### REMARKS

**IN THE DRAWINGS:**

FIG. 6A

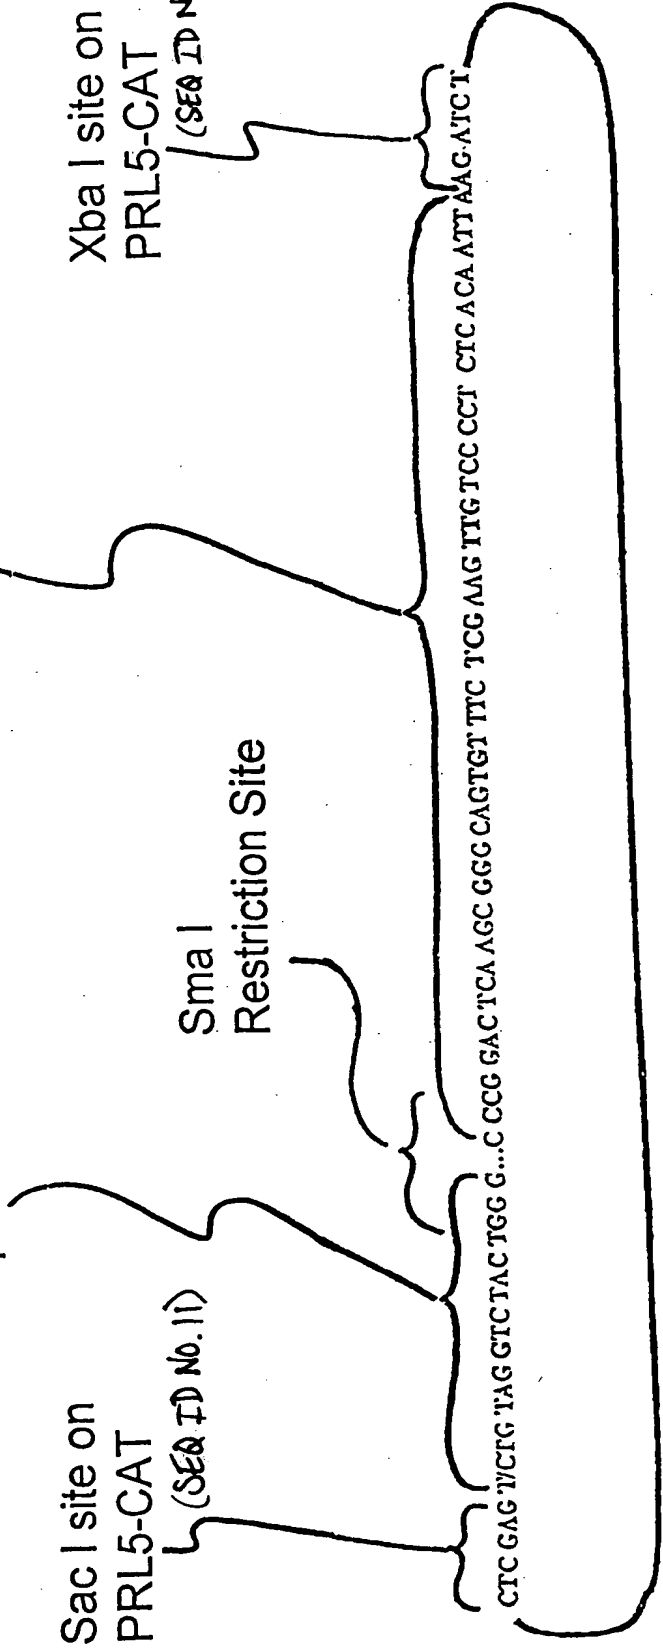
It is respectfully submitted that the Sequence Listing previously submitted (in both computer readable form and in a paper copy) adequately identifies the 14 sequences contained in the subject application. The sequences shown in Figure 6A and 6B were, in fact, included in the previously submitted sequence listing. Figures 6A and 6B are amended herein to more clearly identify those sequences.

Please replace the previously submitted Figures 6A and 6B (which did not contain SEQ. ID NOS.) with the substitute drawings submitted herewith (which include SEQ. ID NOS.).
